State of New Mexico  
 Energy, Minerals and Natural Resources

**SUNDRY NOTICES AND REPORTS ON WELLS**  
 (DO NOT USE THIS FORM FOR PROPOSALS TO DRILL OR TO DEEPEN OR PLUG BACK TO A DIFFERENT RESERVOIR. USE "APPLICATION FOR PERMIT" (FORM C-110) FOR SUCH PROPOSALS.)

Devon Energy respectfully requests to temporarily abandon the Thistle Unit 4 for five years due on-going evaluation and decision on remediation. Revision to previously proposed TA procedure below. Please see attached wellbore schematic.

**PROPOSED WELLBORE TA REVISED**

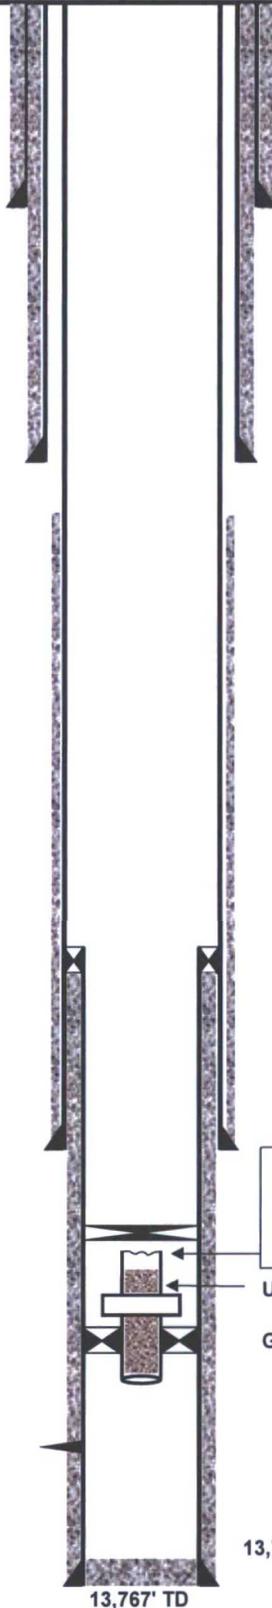
- Cutprod tubing +/-13,320'. POOH w/ prod tubing
- Set CIBP @ +/-13,310'. *CAP w/ 35' of cmt by Wireline*
- Circulate wellbore w/ *field brine*. Run MIT. *packer or inhibited fluid*

**Condition of Approval: notify  
 OCD Hobbs office 24 hours**

**prior of running MIT Test & Chart**
